# ADDENDUM #1

Reference: Utah National Guard  
VA Nursing Home Chapel Addition  
DFCM Project No. 06237480

Utah State Veterans Nursing Home Chapel/Multi-purpose Room Addition  
DFCM Project No. 06237480

ESD-1

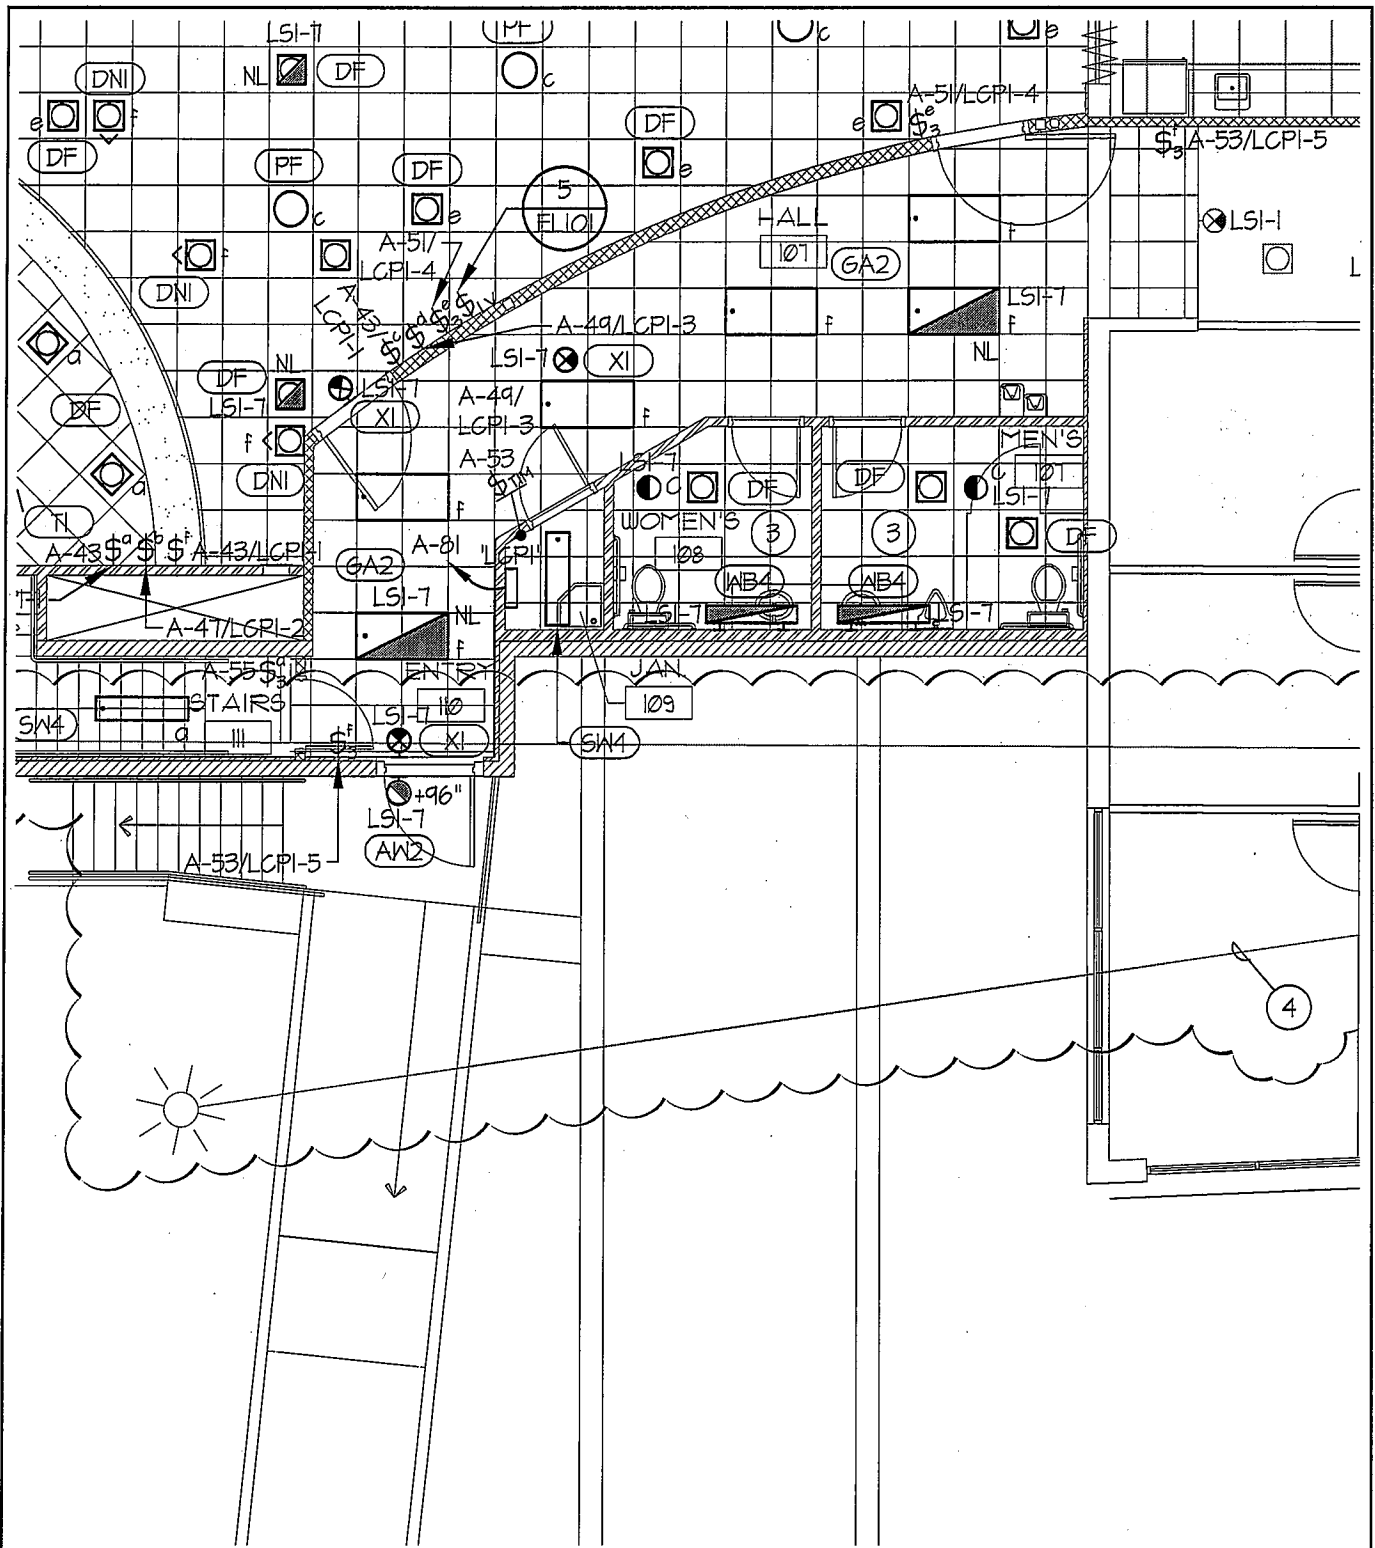
1. ESDs-1, 2, 3, and 4 showing site lighting conduit and conductor routes to contactor cabinet LC1 must remain in service during construction. Conduit routing is shown from the as-built drawings.

- ④ APPROXIMATE SITE LIGHTING ROUTE TO 'LCI' FROM AS-BUILT DRAWINGS. CONTRACTOR TO PREVENT LOSS OF SITE LIGHTING DURING CONSTRUCTION.
